June 13, 2022
Project No. 403215002

Subject: Response to City of Santa Cruz Comments
Proposed Office/Residential Building
2035 North Pacific Avenue
Santa Cruz, California

FIGURE 1

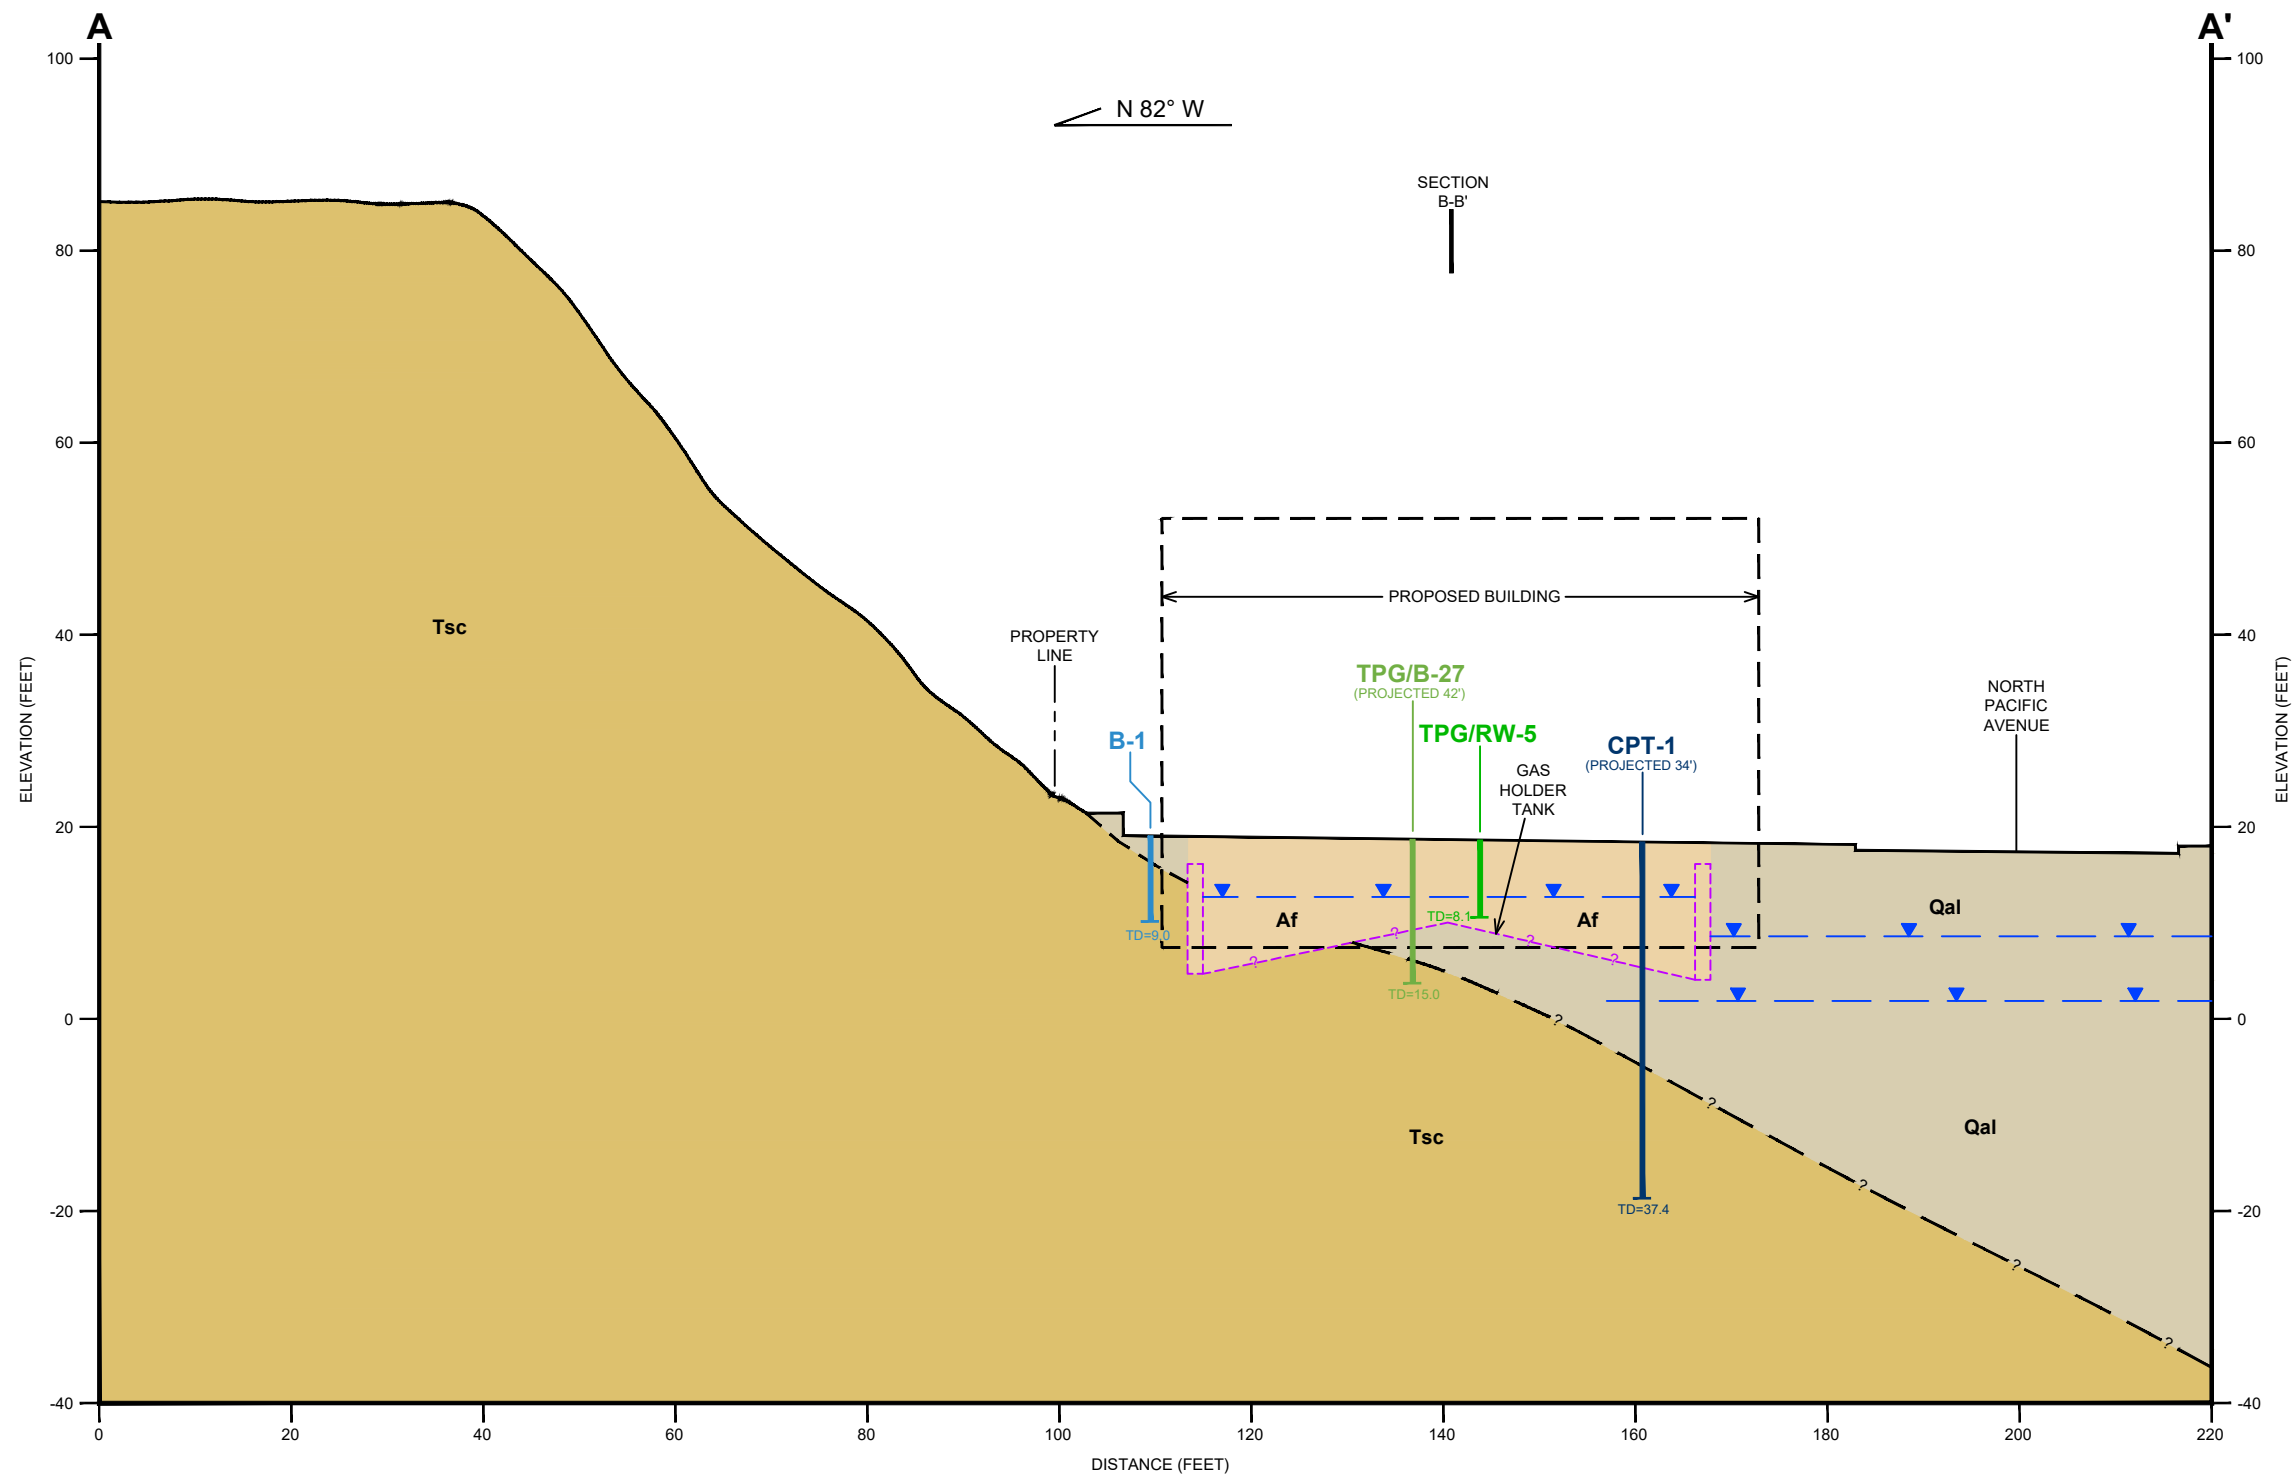
According to the TPG (2013 and 2016) maps, the northern perimeter of the tank foundation lies very close to the building footprint at 201-217 River Street (Figure 1). Based on the information provided in the TPG report, the tank foundation underlying 201-217 River Street was not removed during construction of the current building. In addition, we do not know the type of foundation that supports the building at 201-217 River Street.

According to the TPG (2013) report, dewatering activities to remove the groundwater inside the holder tank were performed between December 18, 2012 and January 18, 2013. Prior to the dewatering program, soil was removed along the southern perimeter of the tank to depths of about 3 to 13 feet (see Figure 1). The dewatering program included the installation of nine dewatering wells (RW series on Figure 1) varying in depth from approximately 8 to 14 feet within the walls of the tank. The depth to water prior to dewatering was measured at approximately 5 feet below ground surface (bgs), and approximately 7 bgs after two phases of pumping. Based on the pumping rates measured during the dewatering program, TPG (2013) concluded that dewatering of the remaining groundwater from the tank could take several months.

According to TPG (2013), perched groundwater was present inside the buried tank and varied in depth from about 5 to 7 feet below the ground surface at the time of their evaluation in December 2012 and January 2013. It is our understanding that the RW series of monitoring wells (RW-1 through RW-9) within the limits of the tank have been destroyed (TPG, 2013), but monitoring wells MW-4 and MW-5 are still present onsite (Figure 1).

FIGURE 2

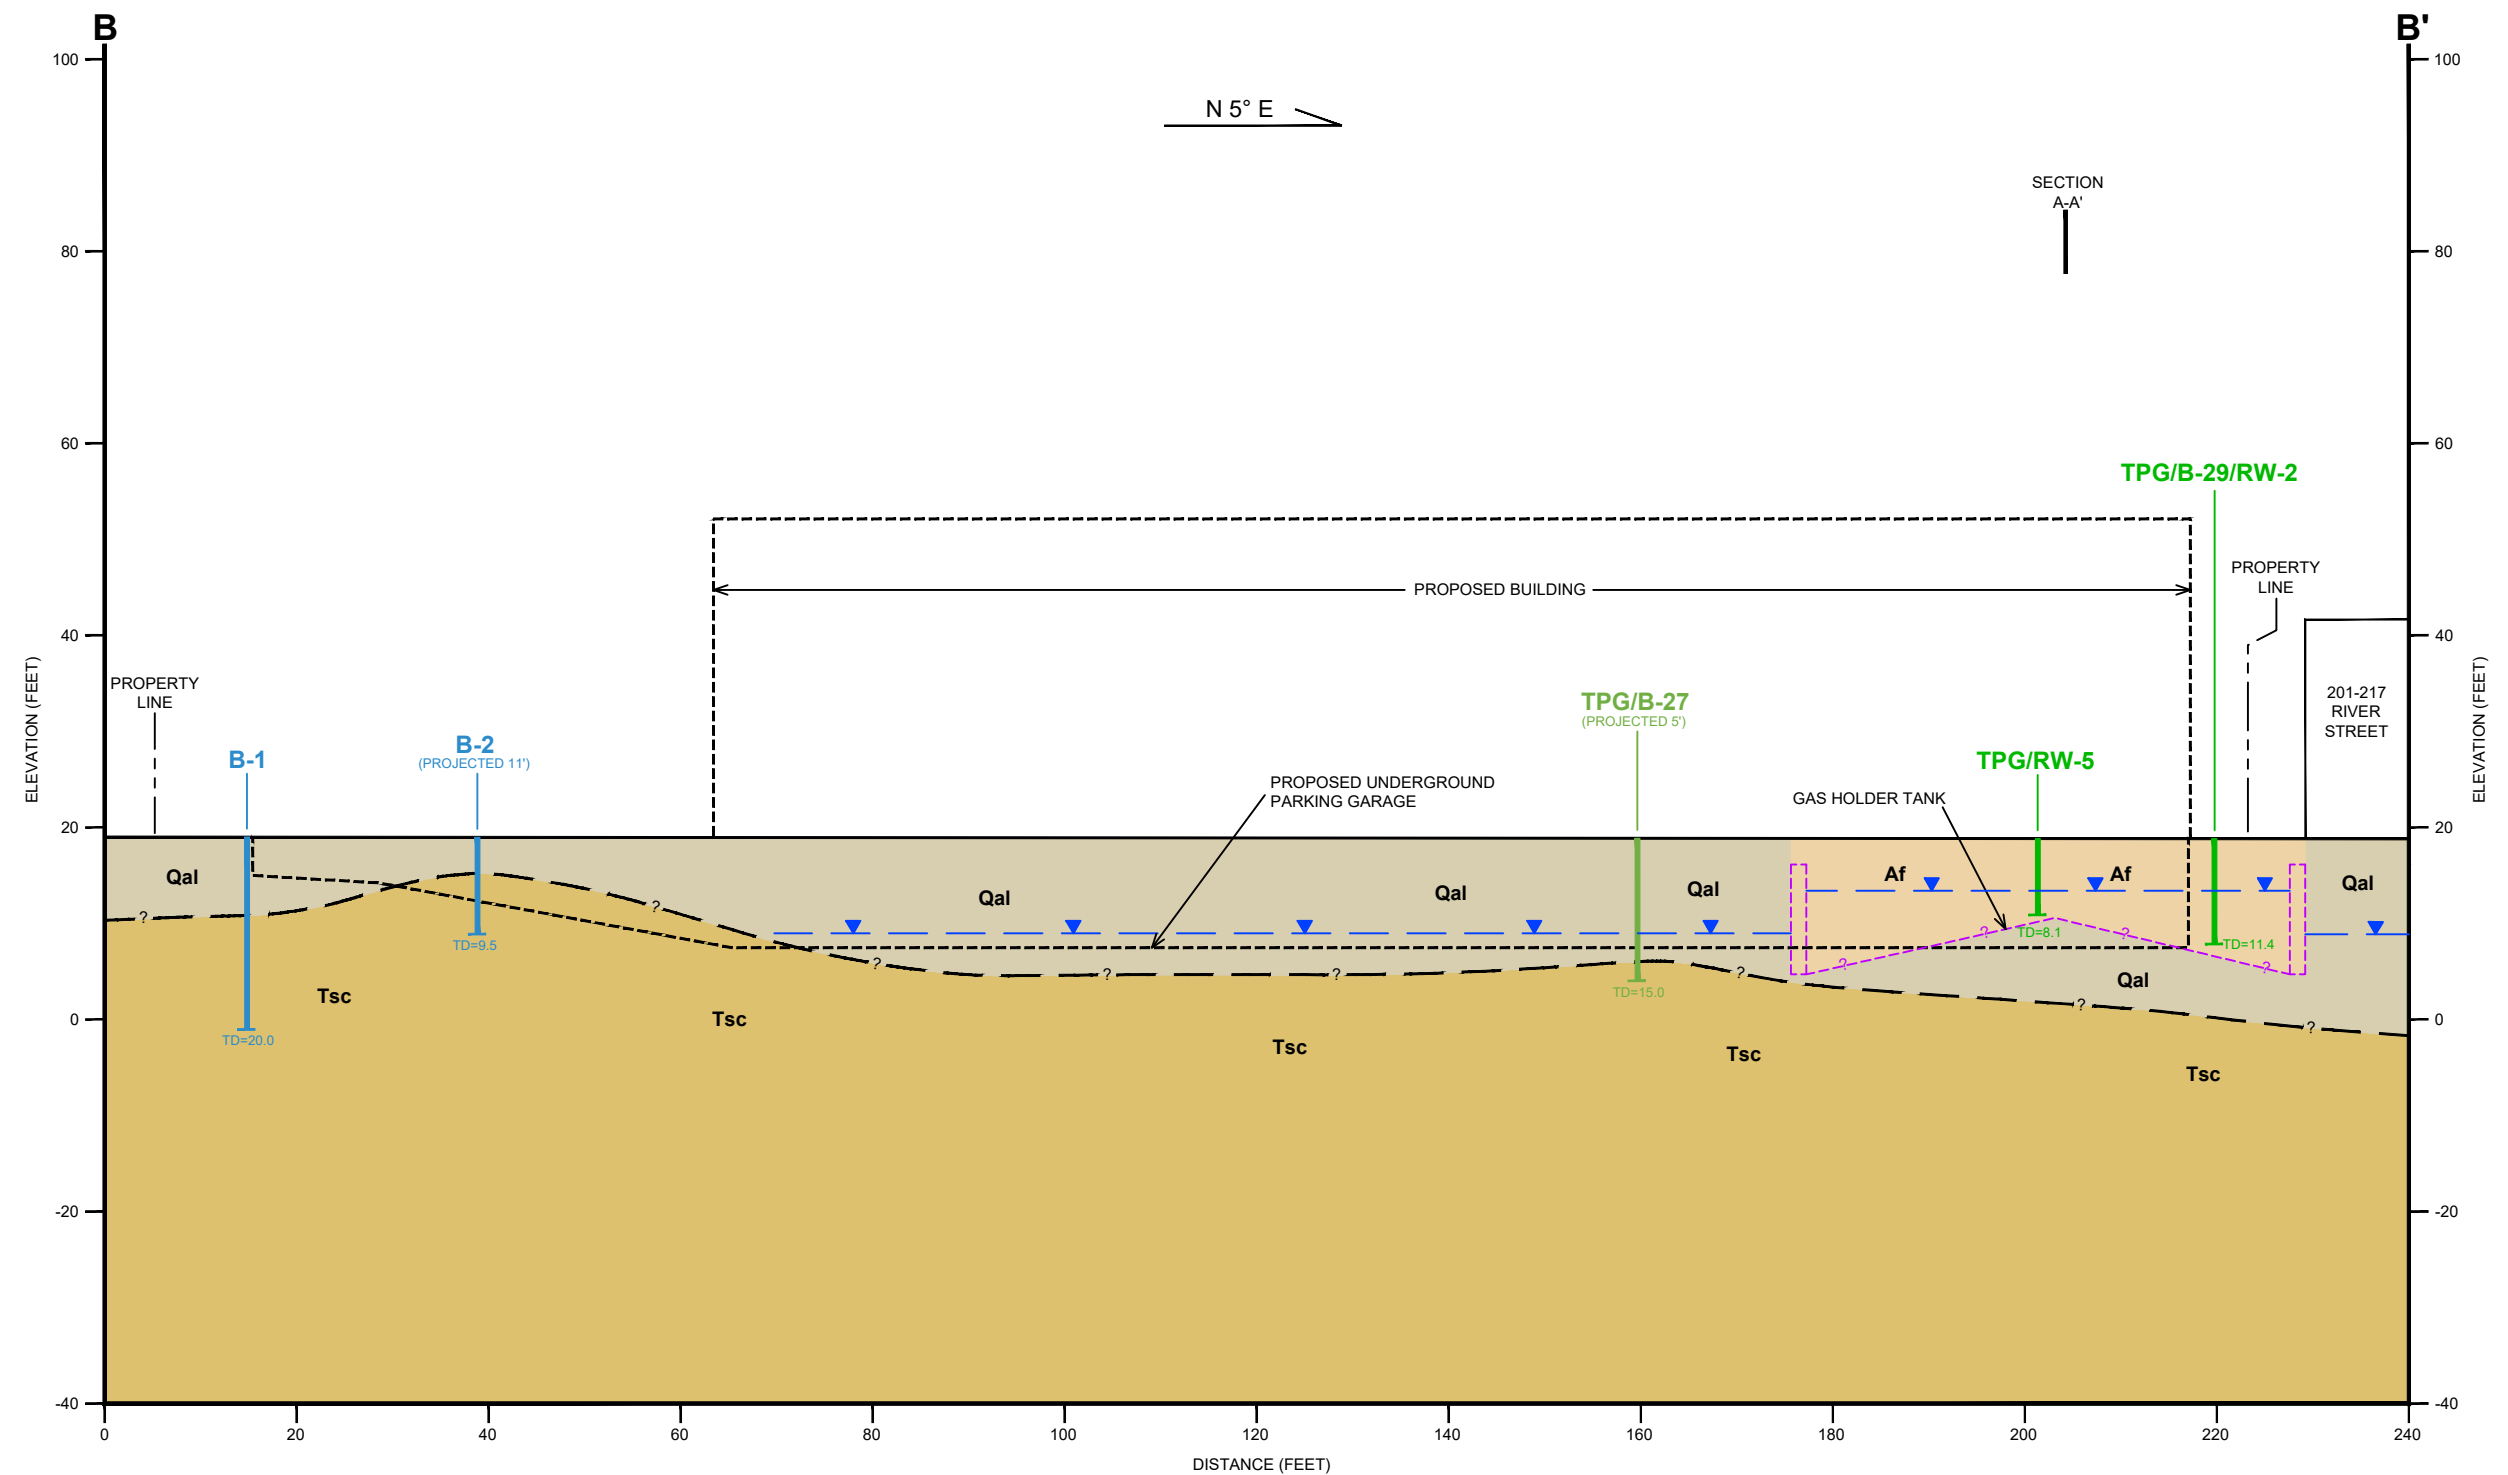
The northern end of the subject property is underlain by fill and alluvium overlying sedimentary bedrock of the Santa Cruz Mudstone. The surficial deposits of fill and alluvium thicken to the east toward North Pacific Avenue (Figure 2). Shoring along the northern end of the excavation for the proposed underground parking garage will transition from shallow bedrock conditions at the west end to surficial deposits of fill and alluvium at the eastern end next to North Pacific Avenue (Figures 1 and 2). The shoring wall will also encounter the buried gas holder tank foundation (Figures 2 and 3).

The ascending natural slope along the western side of the property is approximately 65 feet high and steeply inclined with residential properties along the top (Figure 2). The western side of the excavation for the proposed below-grade parking area will be about 10 feet away from the property line and close to the toe of the slope. Slope stability analyses were performed using the two-dimensional stability analysis program SLOPE/W modeling the long term (with proposed below-grade parking area in place) and temporary (i.e., during removal of the buried tank foundation) conditions in order to evaluate the impact of the proposed site improvements on the westerly ascending slope. Strength parameters used in our stability analyses were based on laboratory testing performed during our 2018 geotechnical evaluation (Ninyo & Moore, 2018). The results of the slope stability analyses indicate that the westerly ascending slope will have a factor of safety of 1.5 or higher in the long run when soldier piles are incorporated into the shoring design (Figure 4). Furthermore, the westerly ascending slope will have a factor of safety of about 1.4 (Figure 5) during the temporary condition (i.e., during removal of the buried tank foundation) incorporating soldier piles into the shoring. The factors of safety presented here indicate that the stability of the subject slope under long-term and temporary conditions will be acceptable and in conformance with the standard of care currently exercised in geotechnical engineering practice.

2035 N. PACIFIC AVENUE FIGURE 4 - FINAL CONDITION

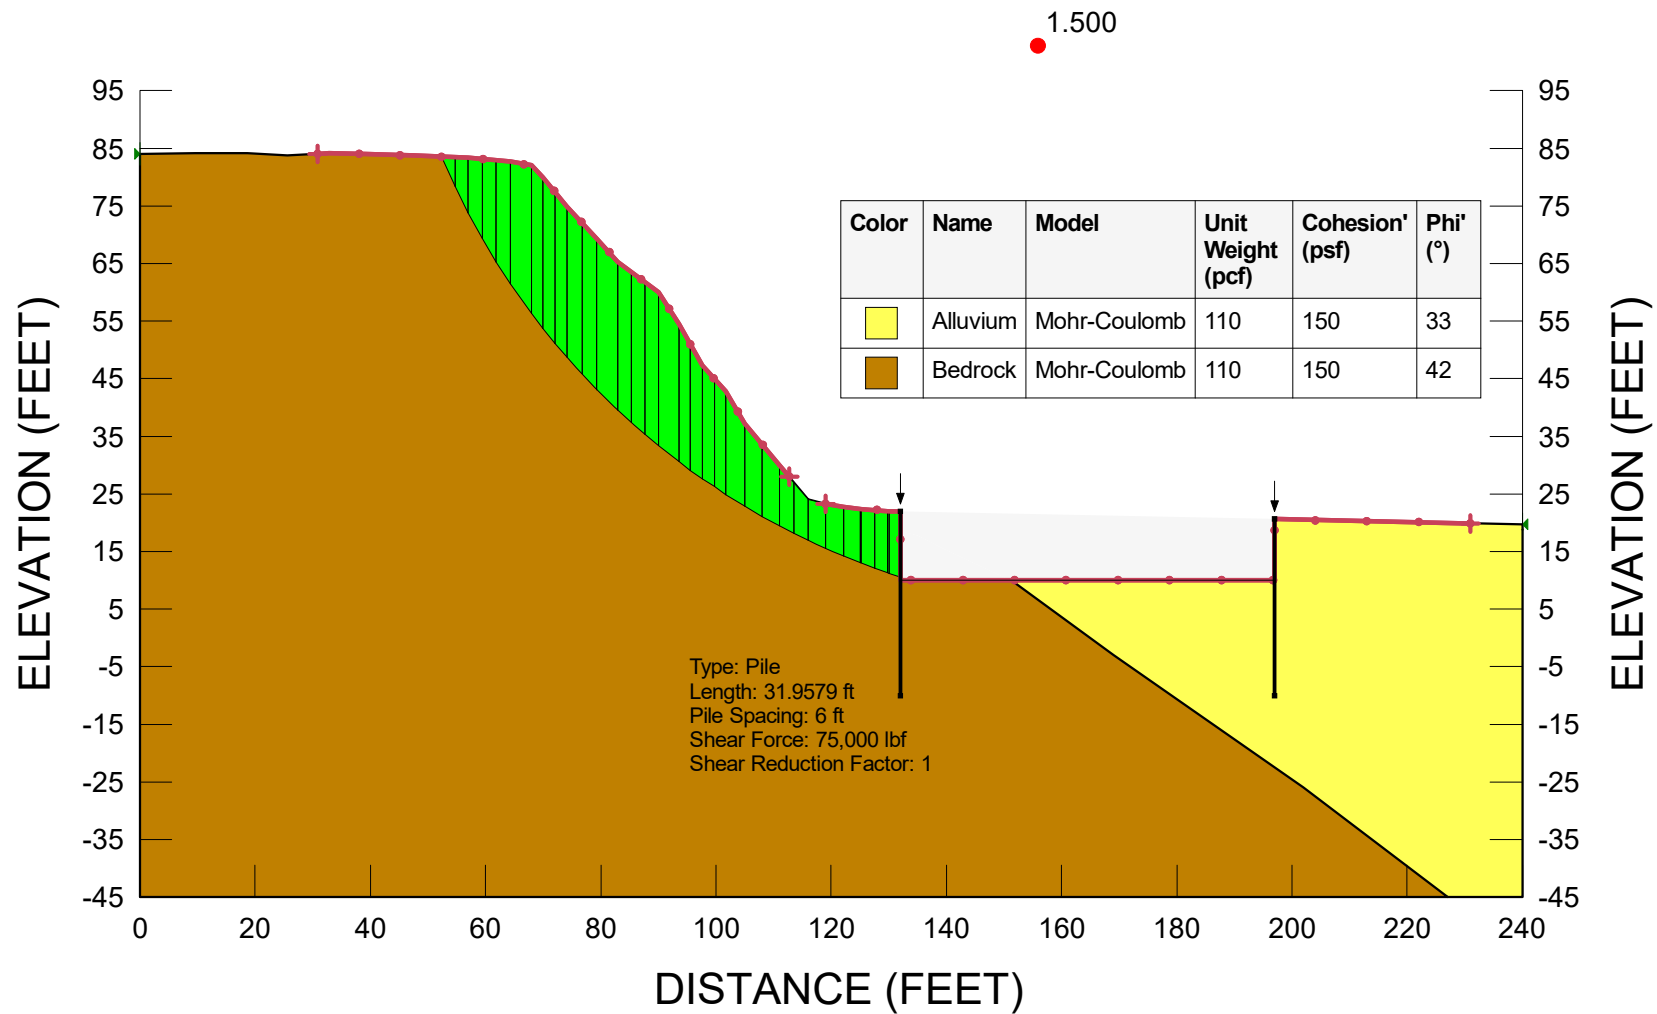
Item 3 – Stability of Ascending Natural Slope and Below-Grade Parking Excavation
